CITY OF FORT LAUDERDALE

# DEVELOPMENT REVIEW COMMITTEE

## CASE COMMENT REPORT

CASE NO. UDP-S24041

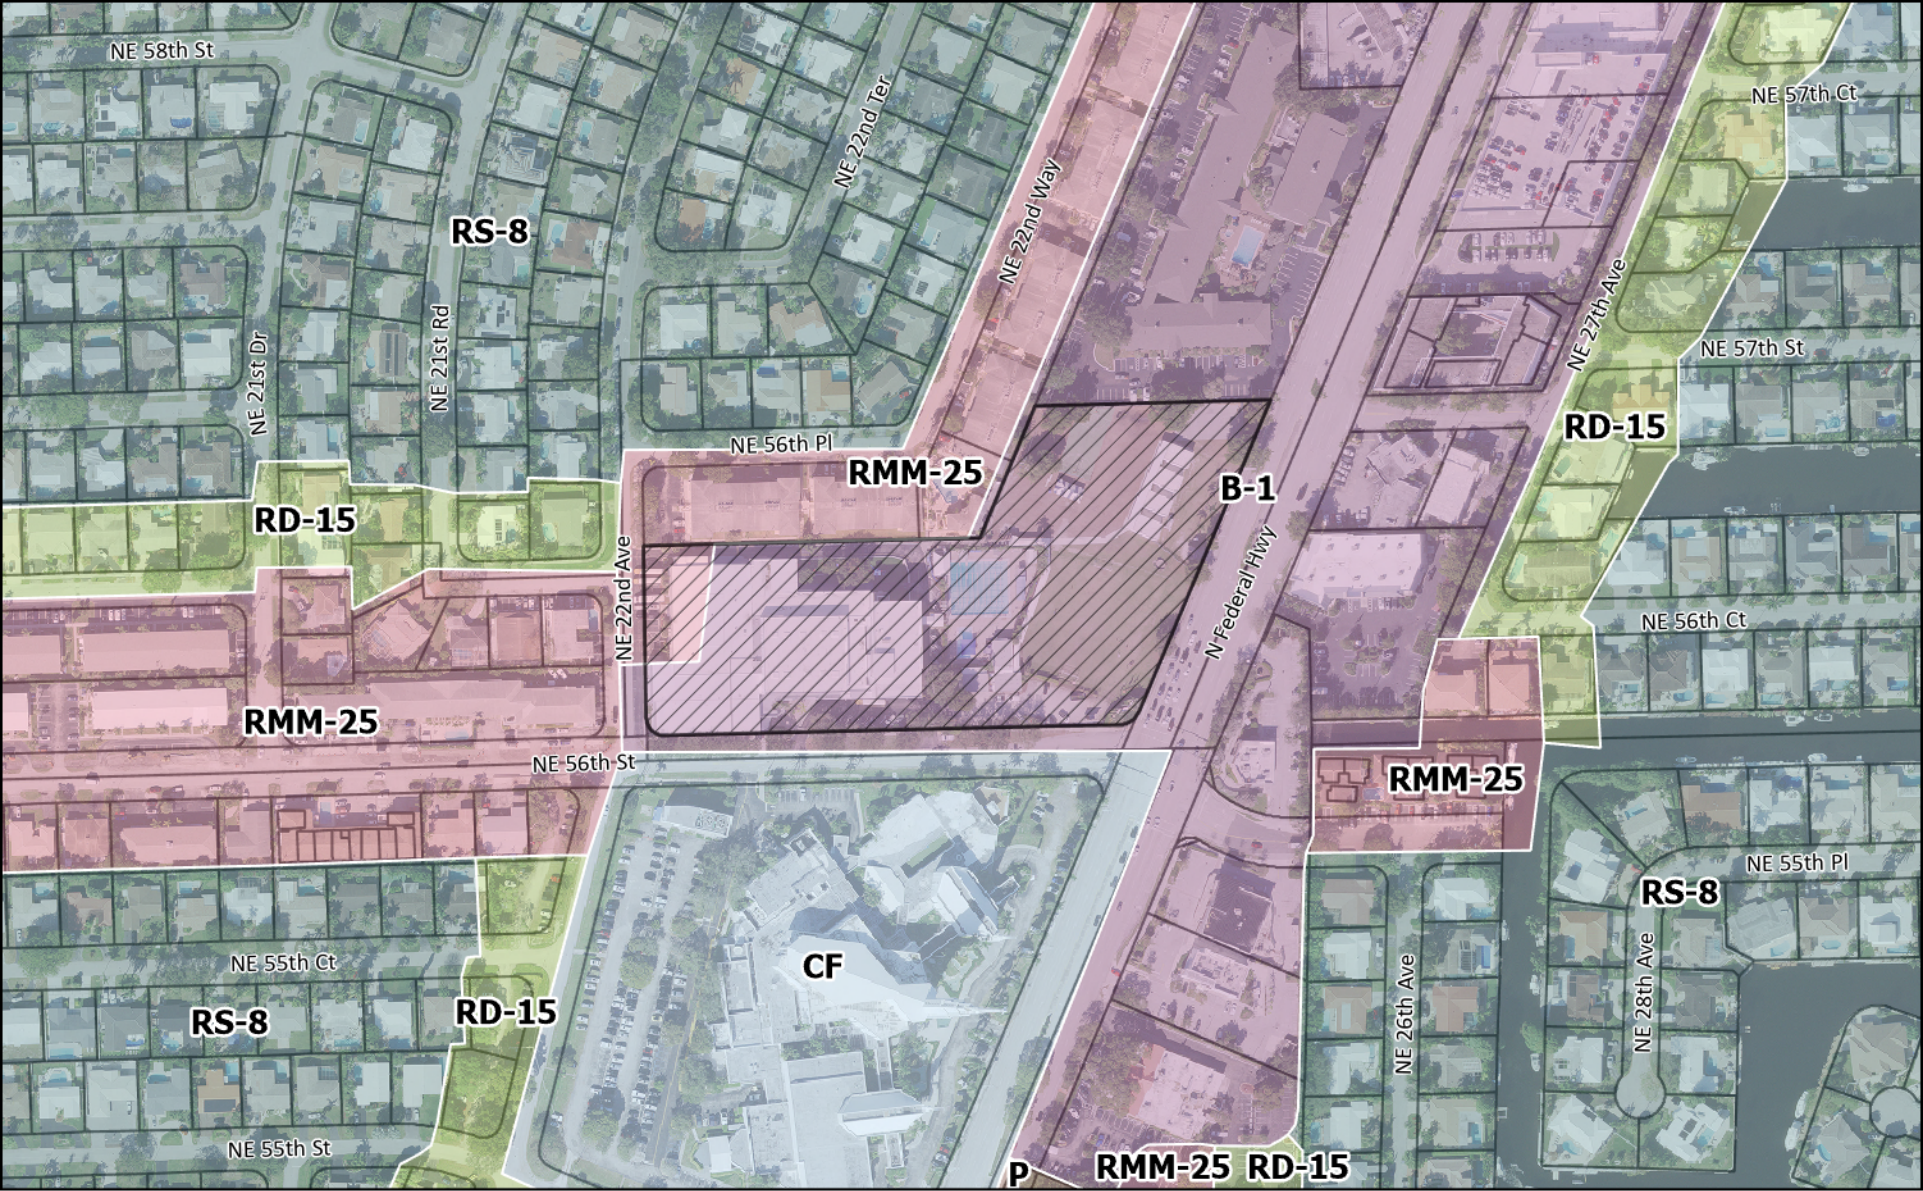
- 17) In regard to physical, communication, and radar obstructions, the Federal Aviation Administration (FAA) requires a review for interference by the proposed construction. Provide a letter from the FAA indicating that such review has been performed. FAA approval must be obtained prior to Pre-PZ, Pre-CC and/or Final-DRC sign-off unless otherwise deemed unnecessary by the City Airport Manager or designee.
